Letter 4

Re: Hetfield Project; Draft EIR dated January 14, 2011

I am writing to comment on the Hetfield Estates Subdivision Environmental Impact Report prepared by Mills Associates dated January 14, 2011 ("DEIR"). I wanted to bring to the attention of the Moraga Planning Commission, the Moraga Planning Department, and to Moraga's consultant, Mills Associates, that there are a number of significant issues the DEIR fails to resolve, without which I believe the proposed DEIR should not be approved. Some of my primary comments and concerns are listed below.

Figure C&R-1 Block Diagram Illustrating Post Grading Conditions as Seen Through Lot 6

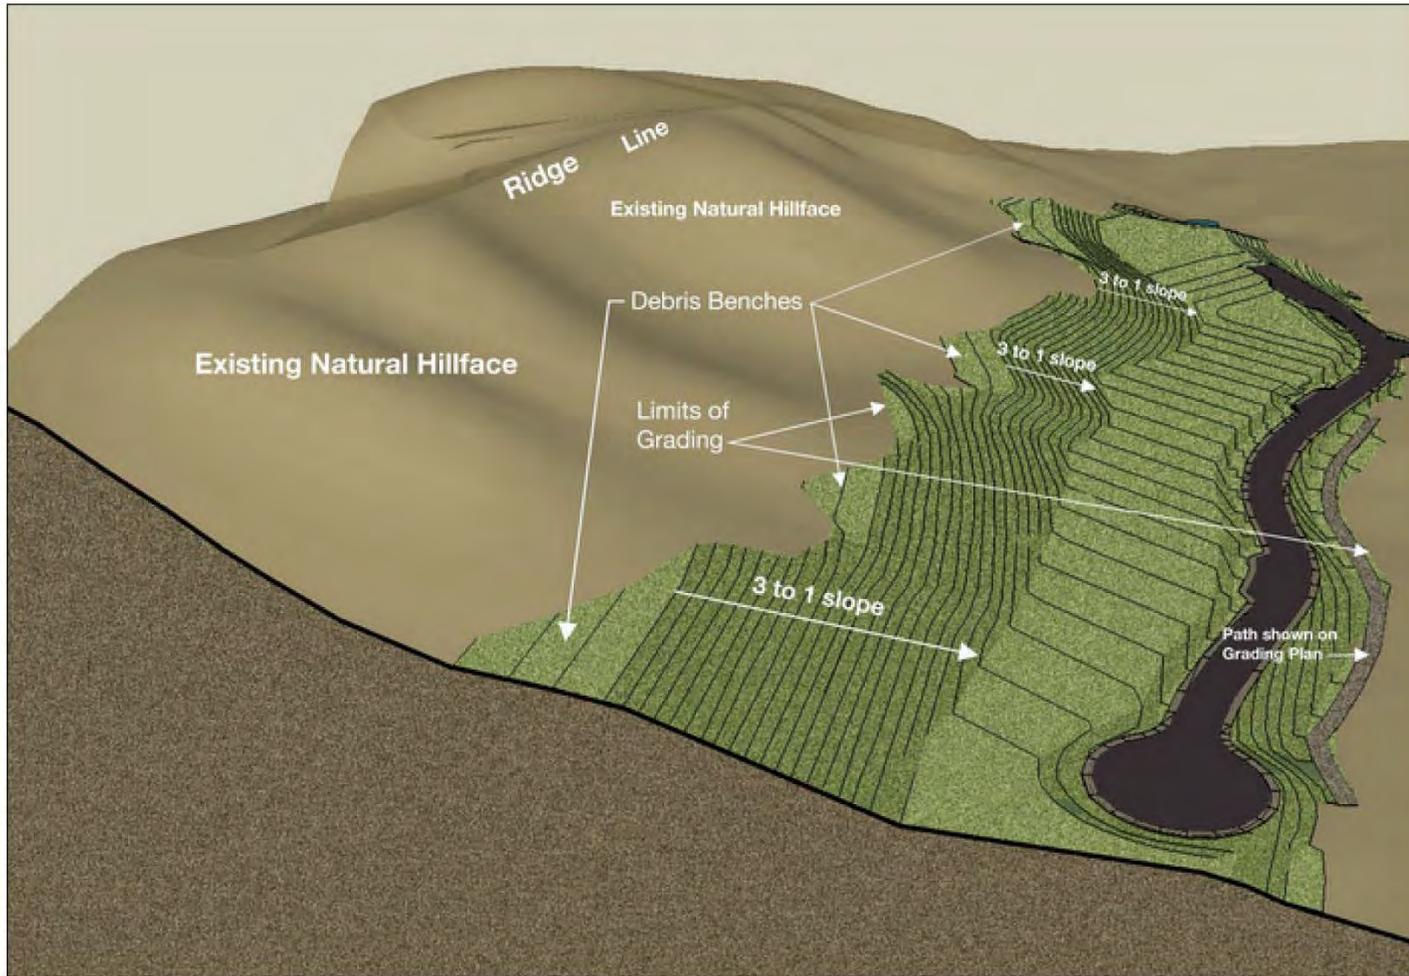
4-4 **Comment:** Concerned that a subdrain system is within the thrust fault setback zone. Grading and landscaping won't look like open space.

Figure C&R-1 is a block diagram that illustrates a birds-eye-view of the proposed grading. This exhibit shows the location of the debris benches, as well grading that is proposed for the residential lots and the on-site road that would provide immediate access to the lots. It does not attempt to show details of landscaping and future improvements to lots. It is based on the corrective grading plan presented in DEIR Figure 3.2-2. Spreading salvaged top soil on the final graded slopes (4 to 6 inches deep) and hydroseeding of the graded area will facilitate dense plant growth during the first winter rainy season.

Figure C&R-2 Geologic Cross Section L-1 - Hypothetical Slide 30 to 35 feet Deep

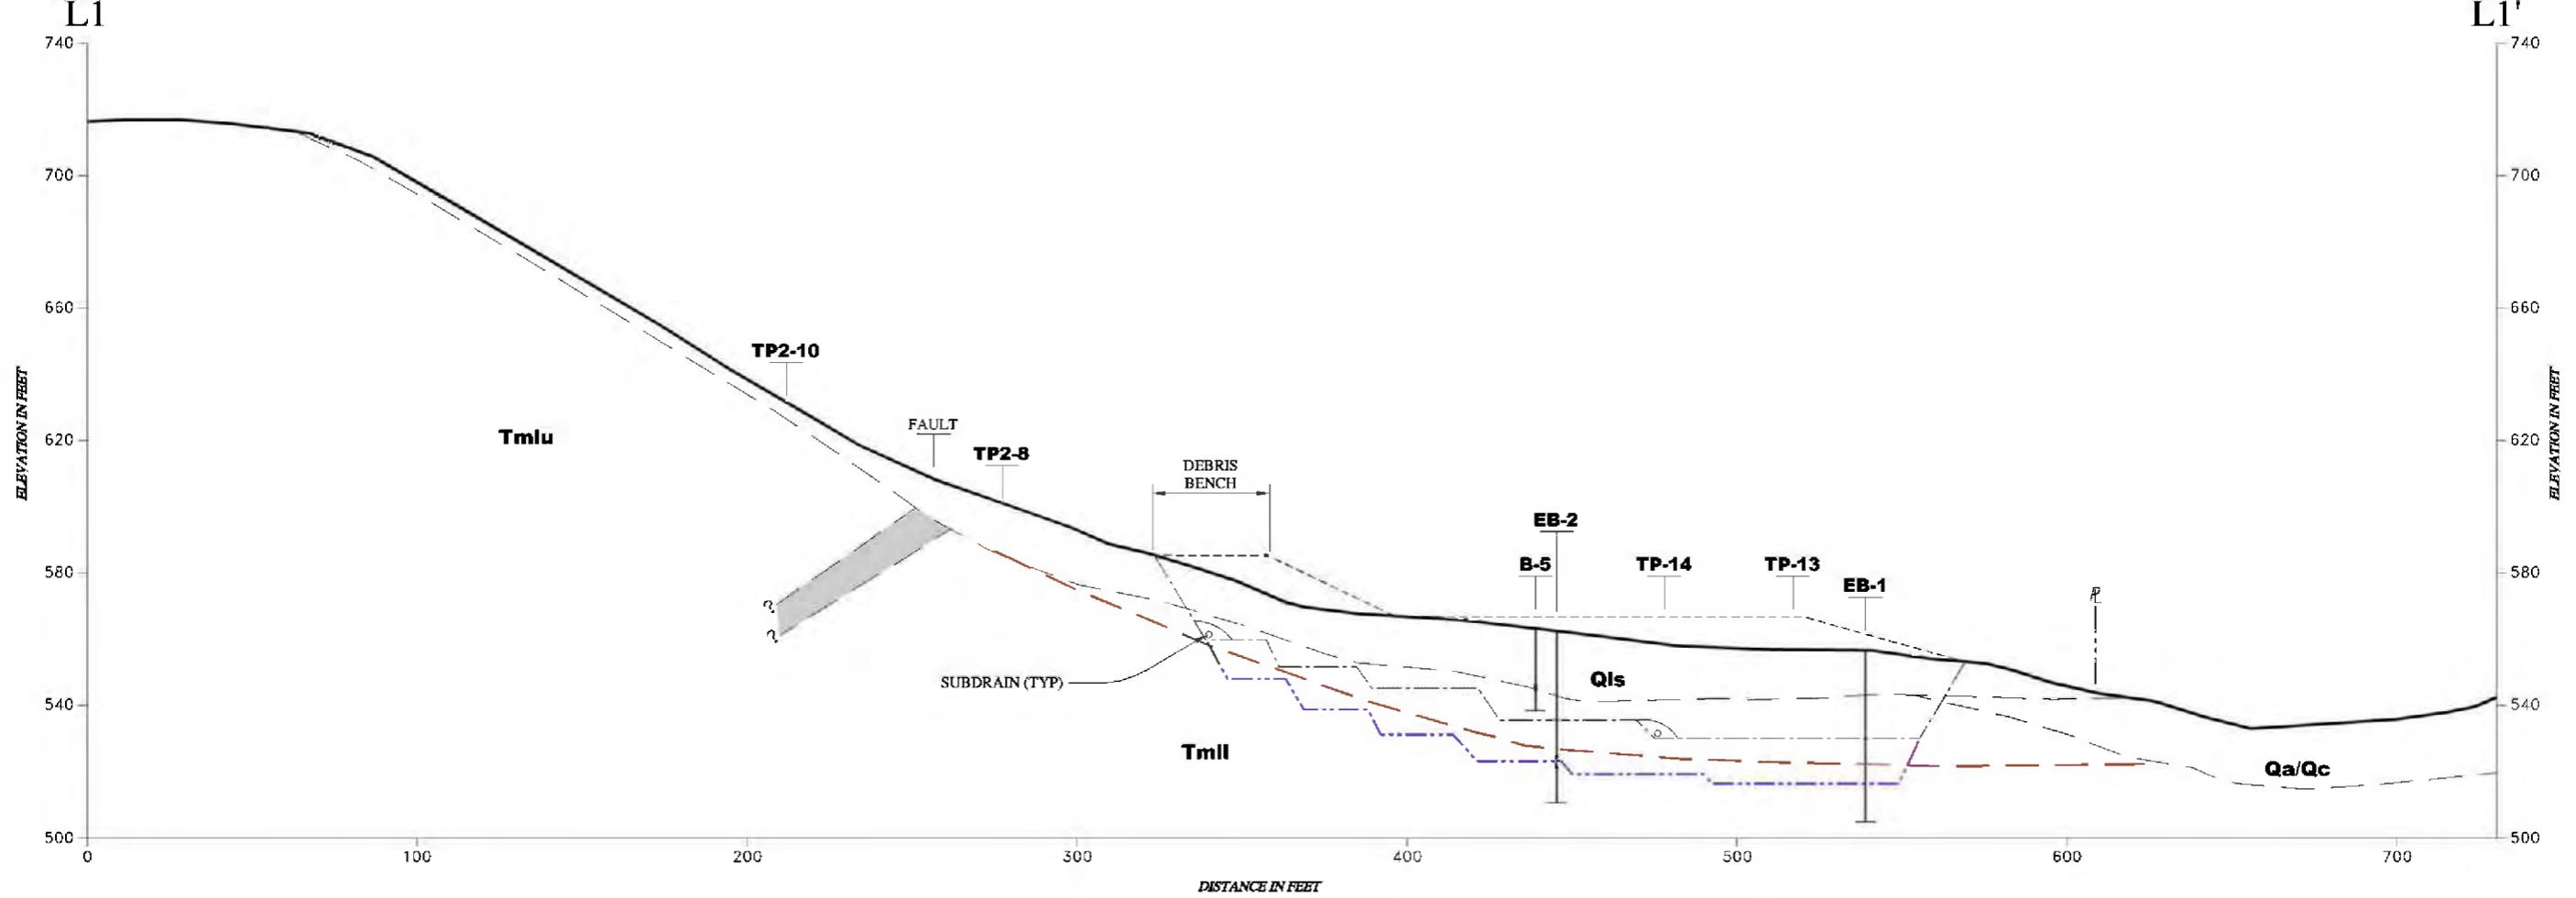
- 4-1 **Comment:** States there was disagreement regarding the diameter and depth of the holes drilled during the supplemental geologic investigation, and therefore, the geological investigation is incomplete and defective.

The report issued by Engeo indicates the following: (a) a high percentage of core recovery was achieved (adequate to draw conclusions on the potential for deep-seated bedrock landsliding), and (b) there was no core loss in the critical areas such as the transitions from highly to slightly weathered rock. The comment letter states that slickensides were found in the bedrock core samples that could be slide related. Engeo disagrees with this observation. In all seven core holes, no slickensides were present that could be interpreted as a basal slide plane. There were some intervals of sheared rock in the cores, but those shears were similar to sheared rock seen in the walls of the exploratory trenches. The trenches were not in a landslide area, so those shears are clearly not related to landsliding. They are reasonably interpreted as the result of tight folding of relatively massive claystone bedrock. For additional pertinent information, see Responses to Comments 2-52 and 2-53.
